Docket Nos. 70-00270
30-02278-MLA
ASLBP No. 90-613-02-MLA
RE: TRUMP-S Project

DECLARATION
OF
TRUMP-S REVIEW PANEL

REBUTTAL DECLARATION OF TRUMP-S REVIEW PANEL

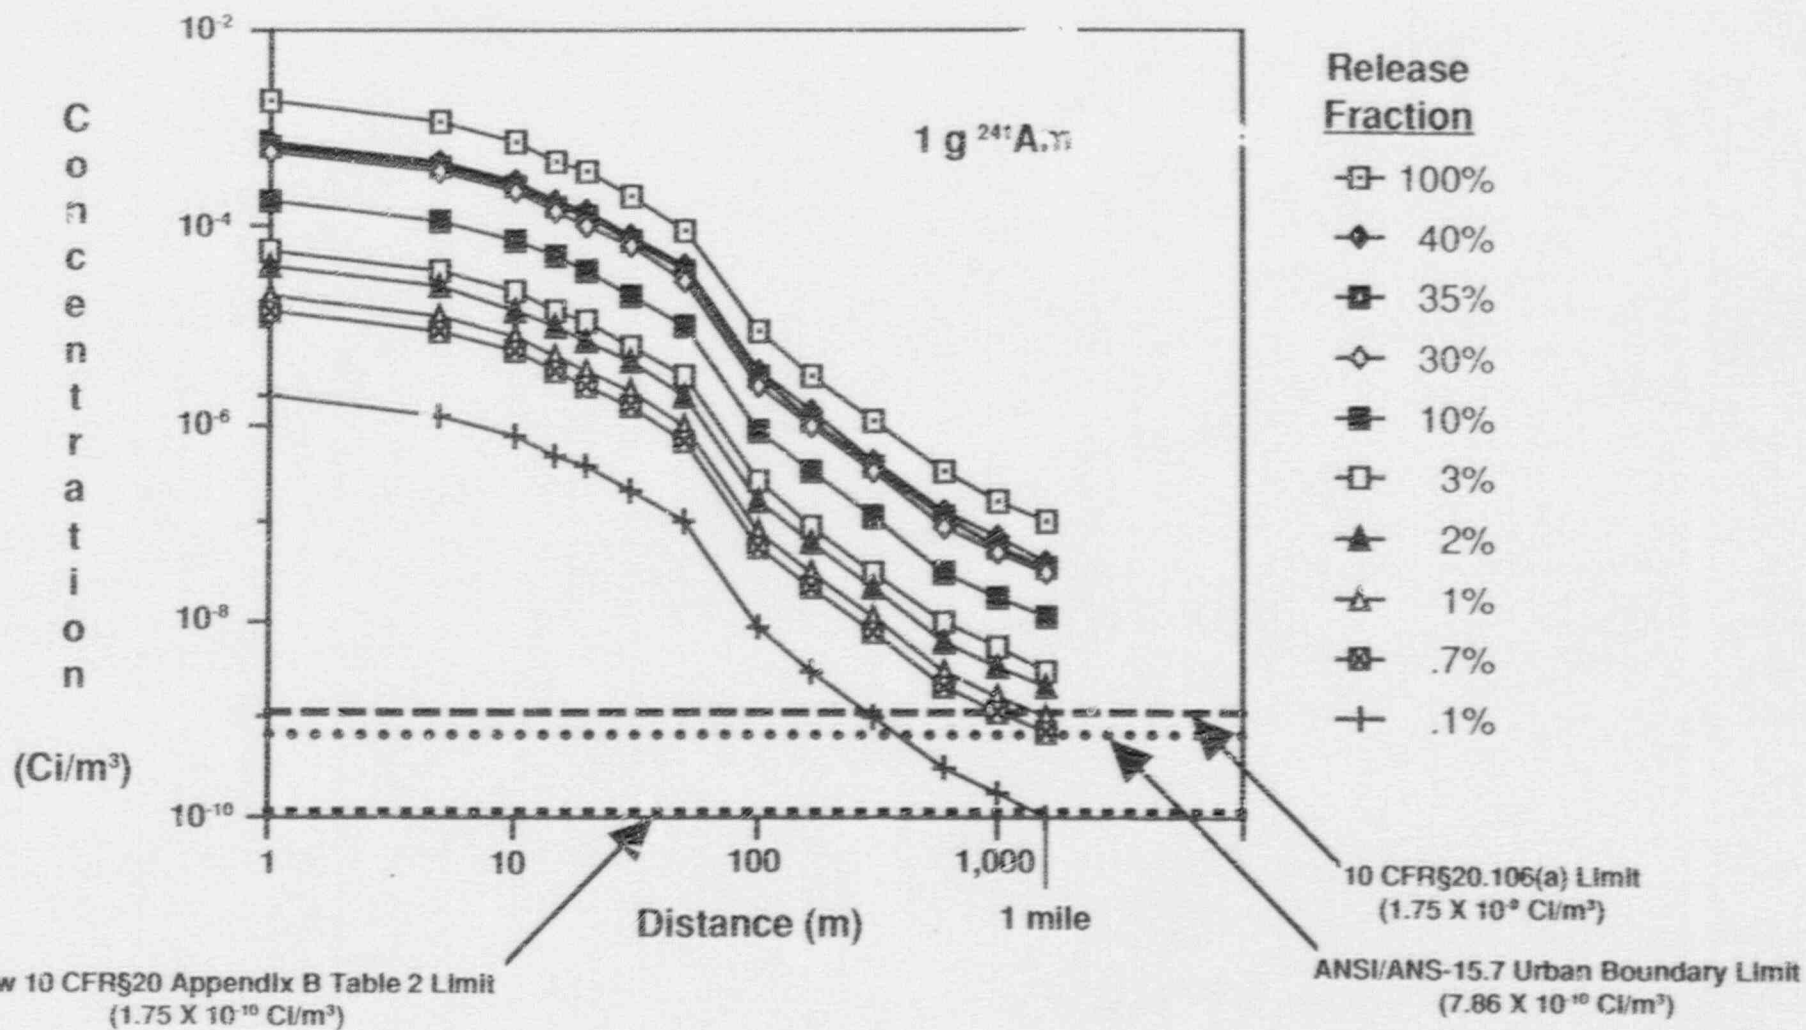
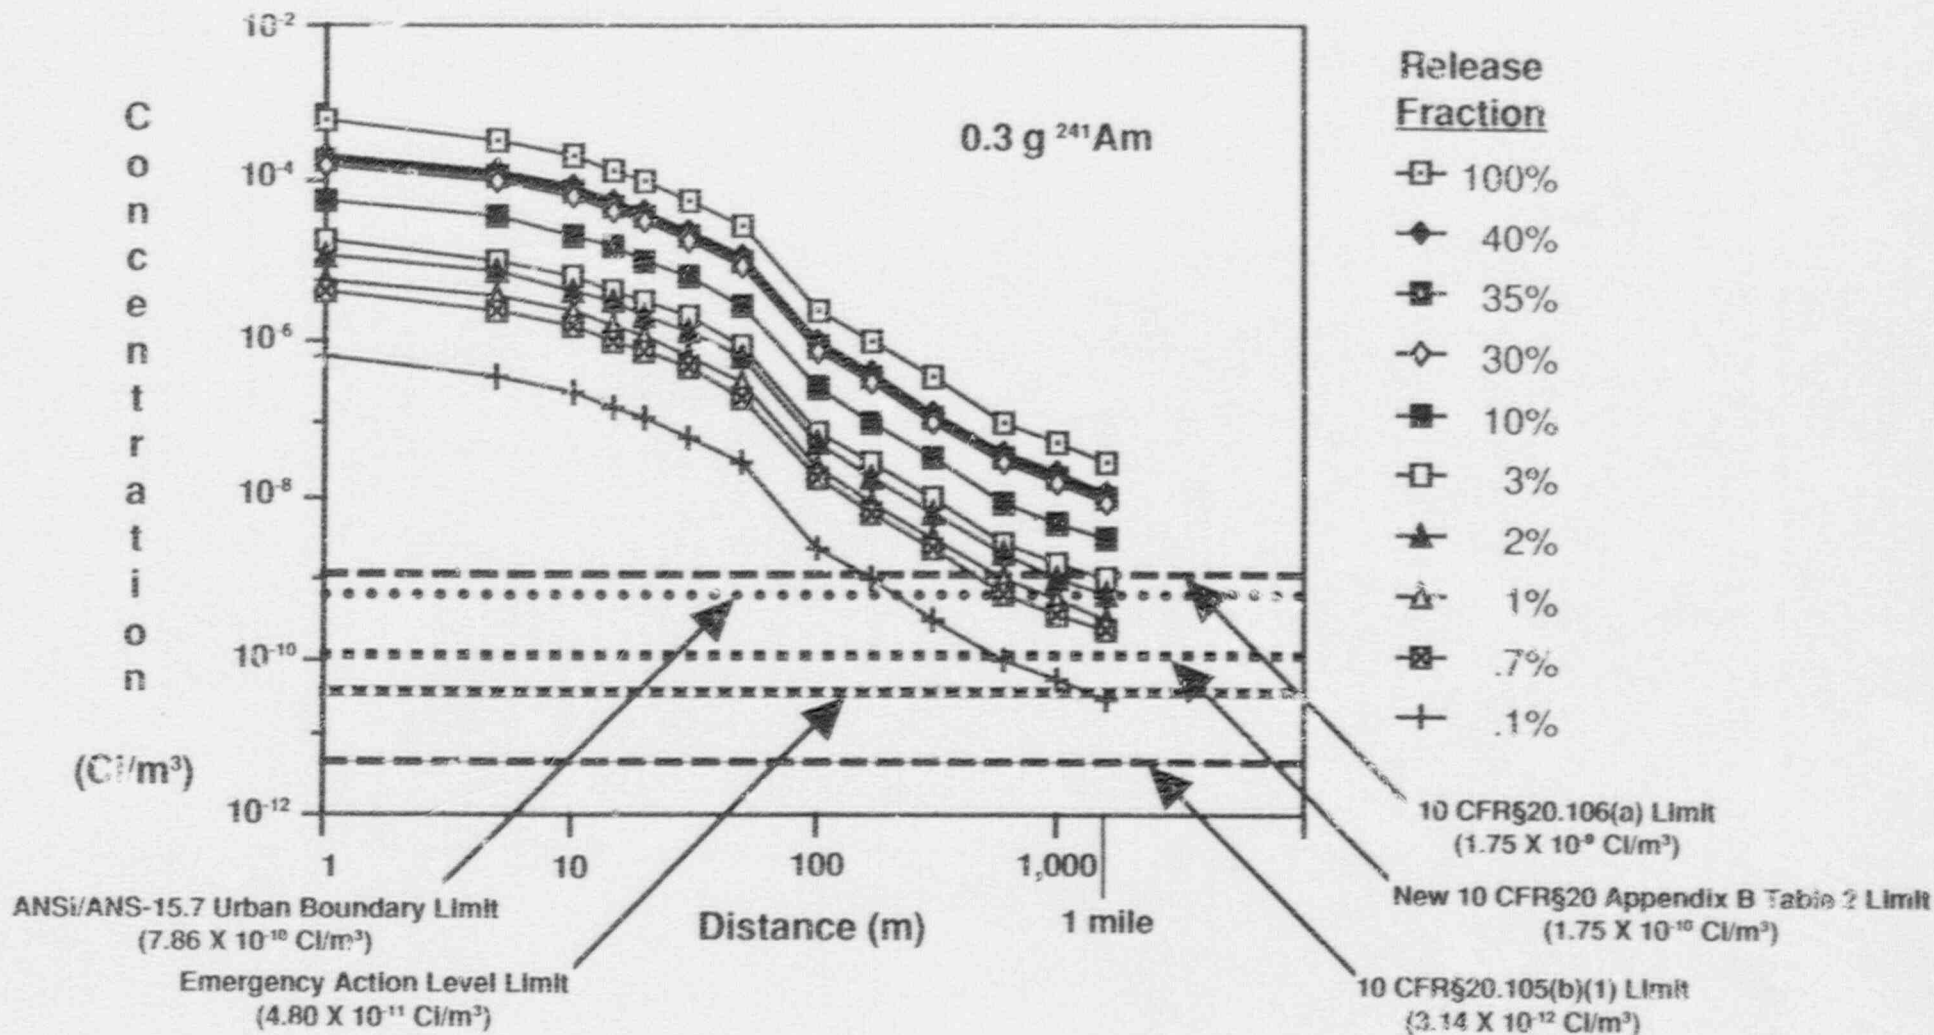
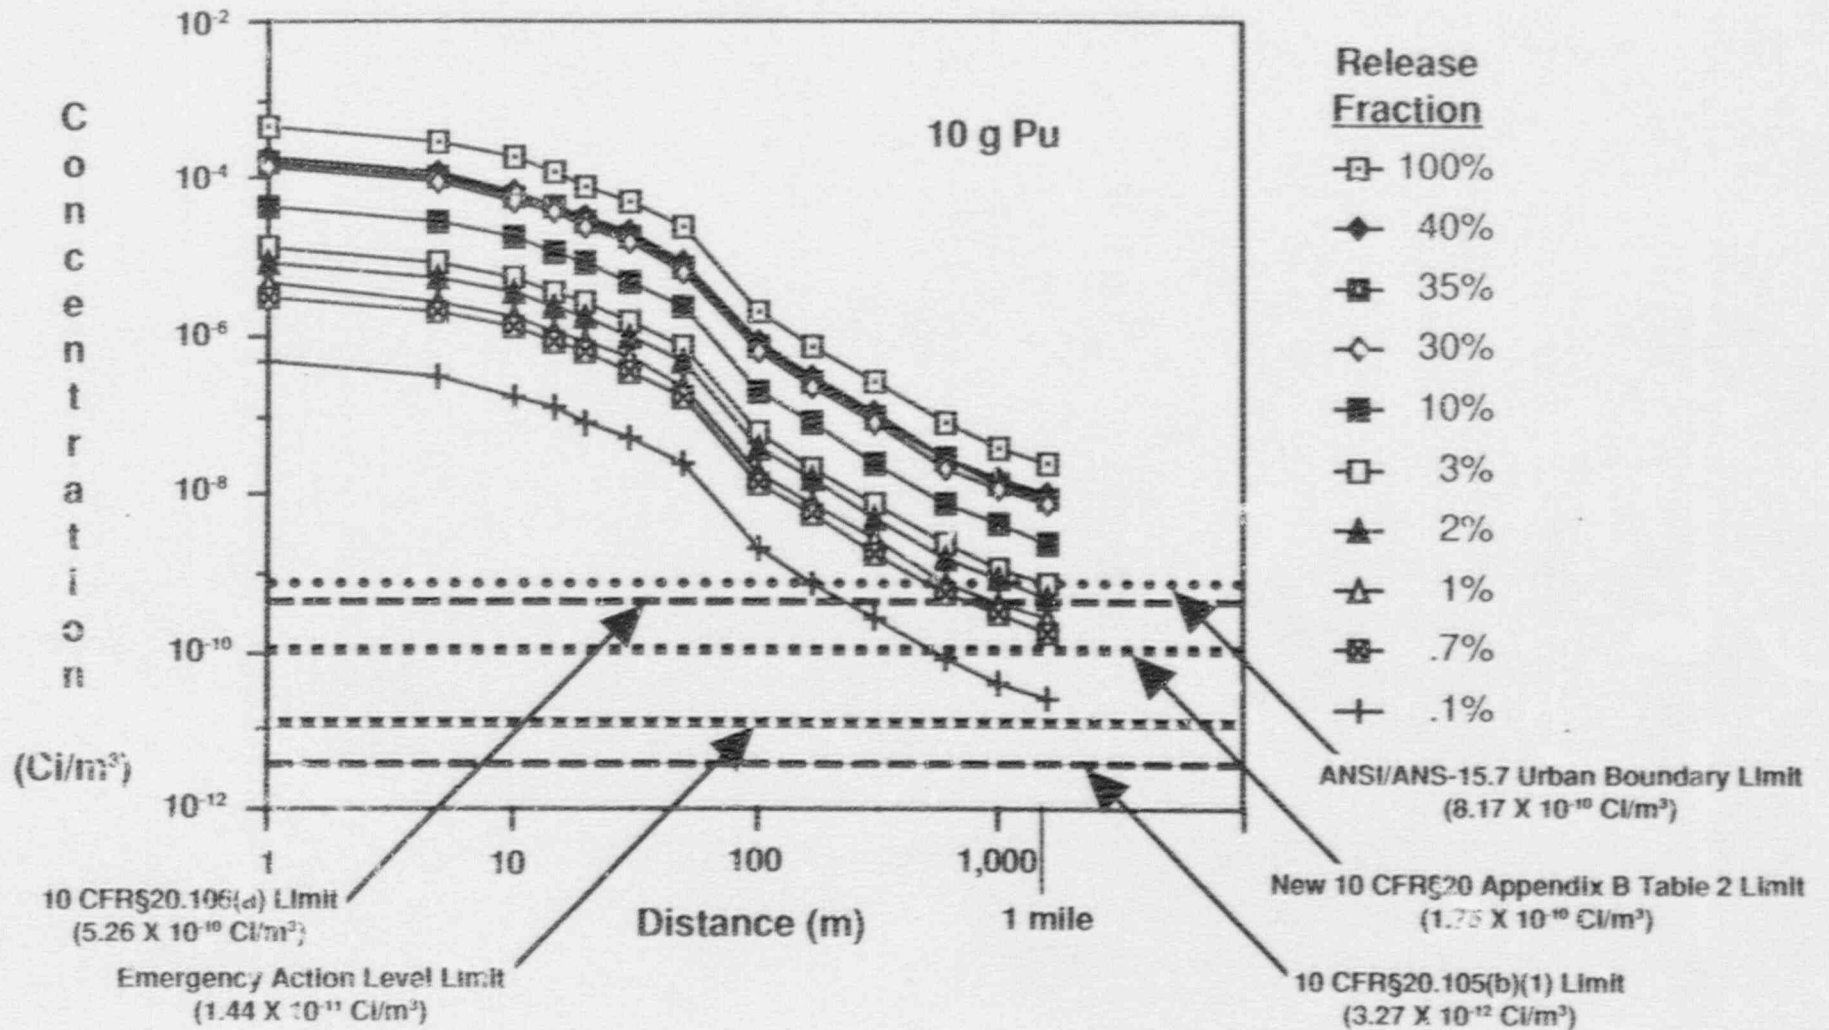
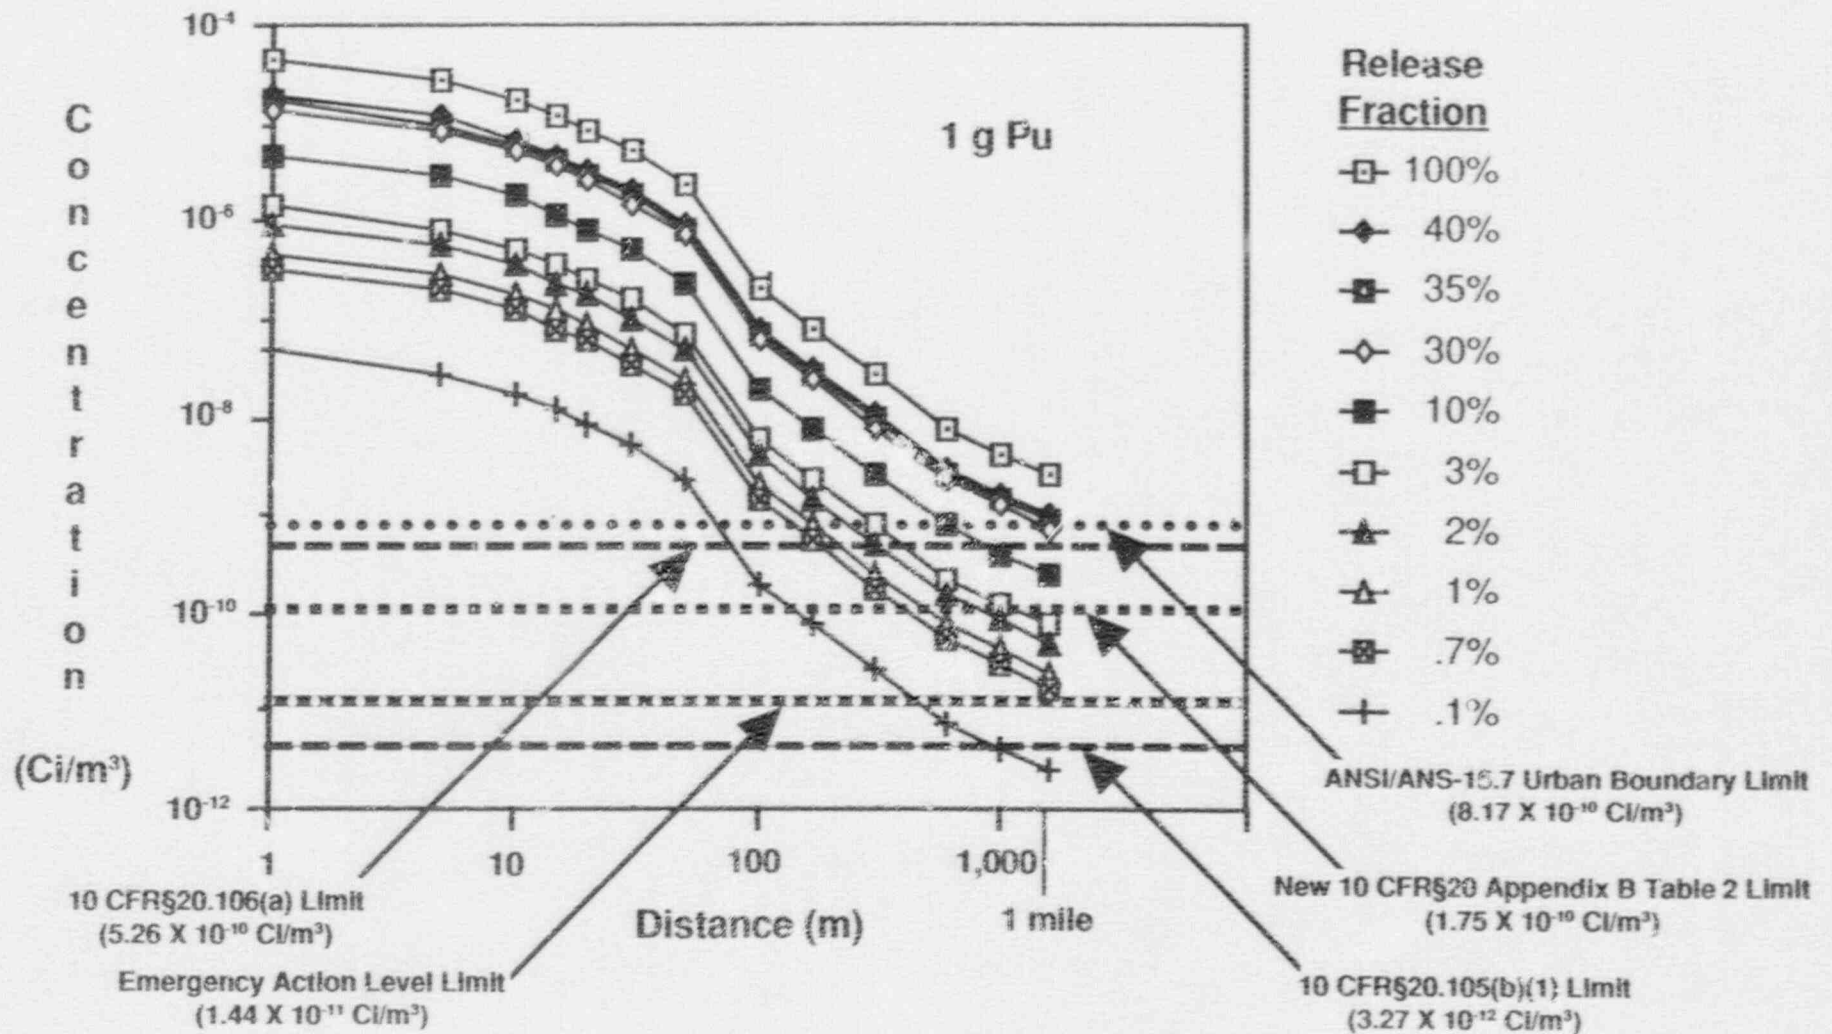
88. The graphs and tables are for the two primary transuranic elements of concern: plutonium and americium. Dispersion for accidents involving each element is calculated at various distances for three starting quantities of material: the licensed possession limit, the licensed in-process limit, and the Applicant's asserted normal process quantity. For each of these three cases, for each element, concentrations are calculated at various distances for a range of release fractions: the NUREG-1140 figure for overheating incidents involving plutonium metal without an external fire (.001), the NUREG-1140 figure for solvent fires involving actinides (up to .007), the 1% release figure used by DOE and found in the VIXEN experiments, the 2% figure found in a 25-minute fire by Seehars, the 3% figure found in an hour fire by Hilliard, the 10% fraction found in a number of experiments by Mishima, and the 30-40-50% fractions found in numerous other tests by Mishima. These last tests led Mishima to conclude: "Releases are such...that to a first approximation half of the active material may be considered to be entrained. A conservative position would be to assume that all such material would be airborne." (Mishima and Schwendiman, "The Amount and Characteristics of Plutonium Made Airborne Under Thermal Stress," BNWL-SA-3379.) This "conservative position" thus represents the top curve on the graphs.

92. Americium is clearly the limiting case. Concentrations so far in excess of permissible are found that it is clear that even were one to assume a fully functioning HEPA filter and a stack release--which are totally unreasonable assumptions, for the reasons detailed earlier, not least of which is the emergency plan to shut off the stack in case of accident--concentrations in excess of acceptable standards are found for most combinations of reasonable release fraction and starting inventory.
